Regulation No. FRENCH DRAFT

UNIFORM PROVISIONS CONCERNING THE APPROVAL OF CHILD RESTRAINT SYSTEM USED
ONBOARD OF MOTOR VEHICLES.

Regulation No. FRENCH DRAFT
 UNIFORM PROVISIONS CONCERNING THE APPROVAL OF CHILD RETRAINT SYTSEMS USED
 ONBOARD OF MOTOR VEHICLES.

Remarks from Hans Ammerlaan - NL MOT/RDW

Figure 2:
Arrangement for testing
a rearward-facing device

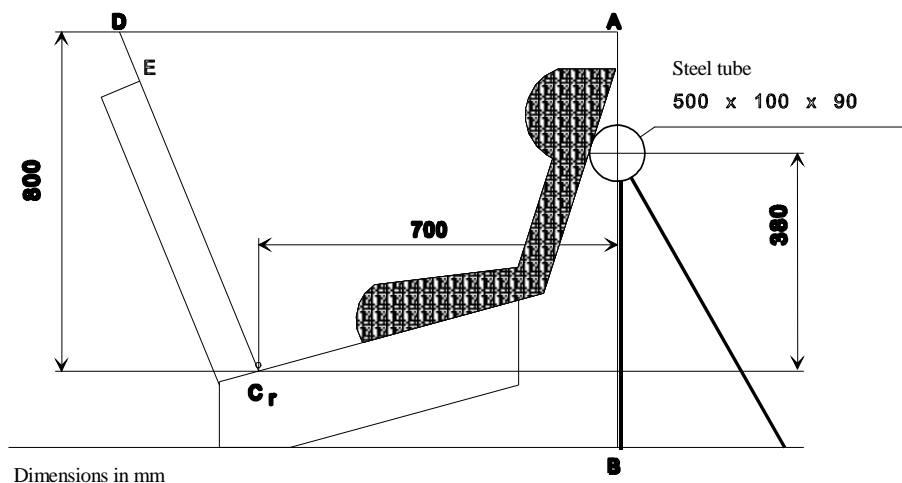
Remark: figure below with support by dashboard not needed anymore must be deleted

Figure 3 -
Arrangement for testing child restraint devices group 0,
not supported by the dashboard

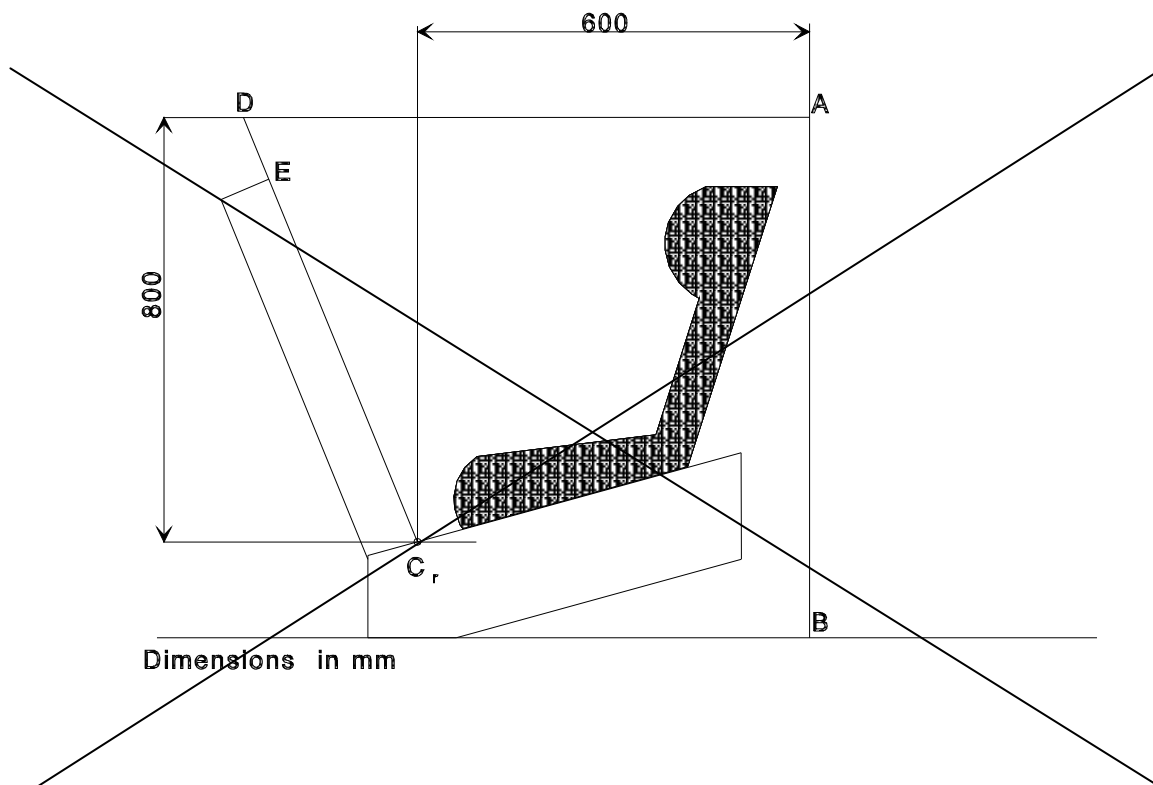
Remark: figure below with distance of 600 not needed anymore must be deleted

Figure 4:

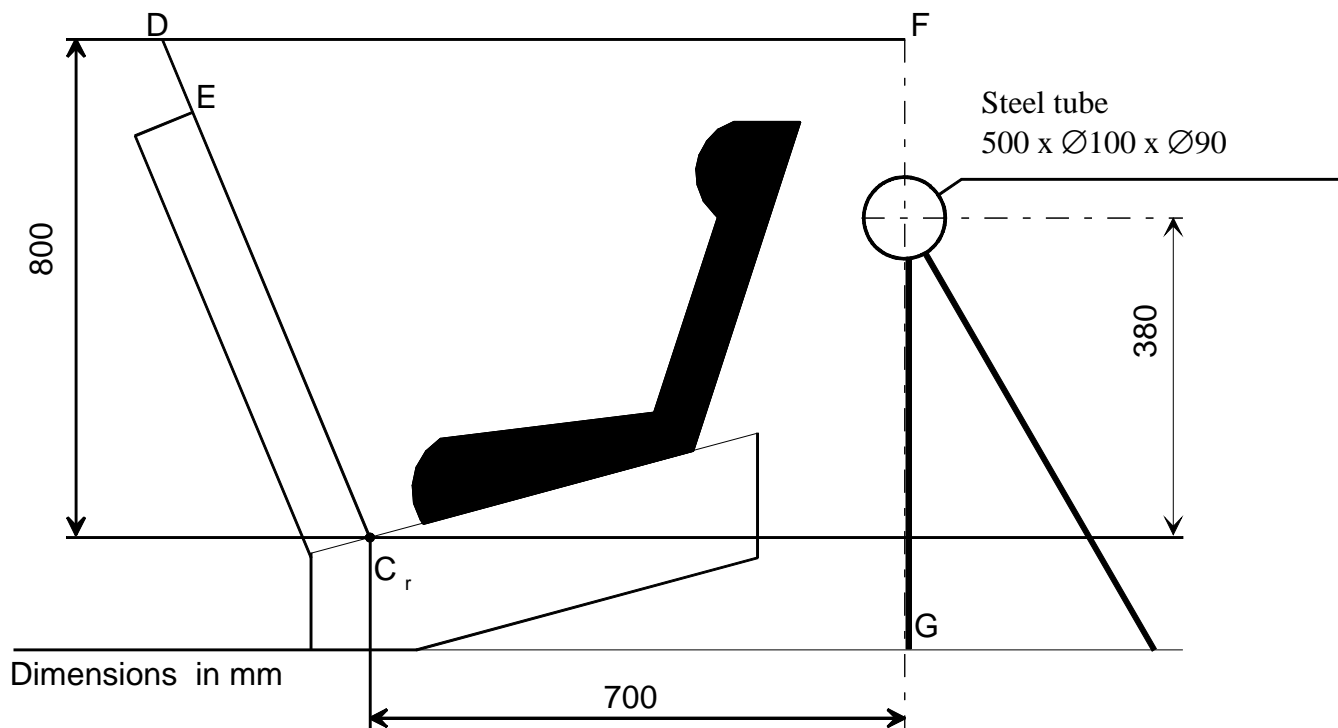
6.6.4.4.1.2.2. Head excursion: no part of the head of the manikin shall not pass beyond the planes FD, FG and DE, as shown in Figure 4 below. This shall be judged up to 300 ms or the moment that the manikin has come to a definitive standstill whatever occurs first.

Remark: now from the point of view that a distance from Cr point to dashboard of 700 mm will be an accepted measure, it should be safeguarded that front passenger car seats can offer this space (after normal adjustment of the seat).
